Subject: **Henderson County Animal Shelter**
828 Stoney Mountain Road
Hendersonville, NC 28791
(FSE File No: 230007)

Pursuant to your request, Paul Fama P.E. visited the subject facility on January 16, 2024. The purpose of our site visit was to observe the proposed locations for the five new roof top mechanical units (RTU) and determine if the existing structure could safely support the weight of the new units. To assist in our evaluation, you provided the existing architectural drawings for our review and the written specifications for the proposed new units. The following is a brief report of our basis of evaluation, opinions, and recommendations.

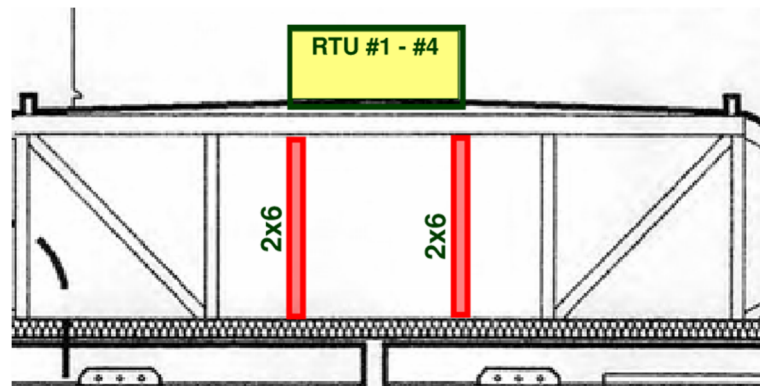
Based on the information provided and our site observations, we understand that the new RTUs will be located on top of the roof at the locations indicated on the plan below that you provided. The existing roof structure consists of prefabricated wood roof trusses spaced at 24 inches on center with plywood roof sheathing. The existing architectural drawings indicate that the attic trusses shall be designed with a 40 psf live load capacity in the attic areas. The total weight of each proposed roof top unit is 983 lbs and has a footprint area of 40 psf. Four of the units will be located directly above the attic areas. RTU #5 is located above the Dog Kennel area which does not appear to be attic trusses. RTU #5 will be located directly above the CMU wall at room 127 Dog Observation Runs.

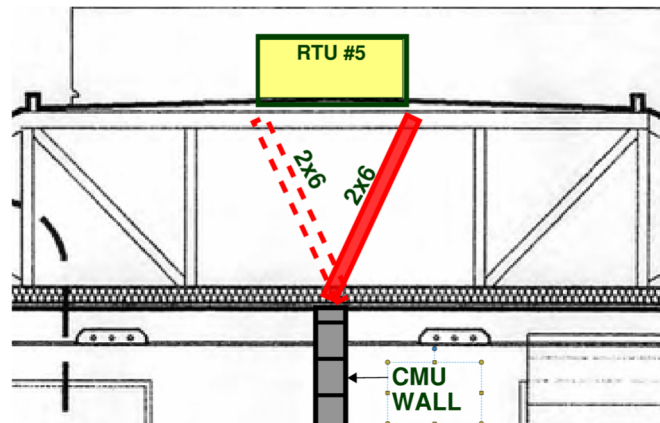
- 2x6 SYP. NO. 2 blocking shall be installed between the trusses below the support locations of all RTUs, and the perimeter of the units. The blocking shall be attached to the existing trusses with Simpson LUS26 face mount metal joists hangers with (6) 0.162" diameter X 3 1/2" common nails.
- The existing roof trusses shall not be cut, notch or modified for RTU installation.
- All existing storage boxes and files shall be removed from the attic areas.
- All existing mechanical units shall be removed from the attic areas.
- RTU #1, #2, #3 and #4 - Install two vertical 2x6's below the RTU #1 through #4. Attached the 2x6's, one between the top and bottom chords below the new RTU (four trusses minimum). Fasten each 2x6 to the existing chords with (2) 0.162" diameter X 3 1/2" common nails. See sketch below:
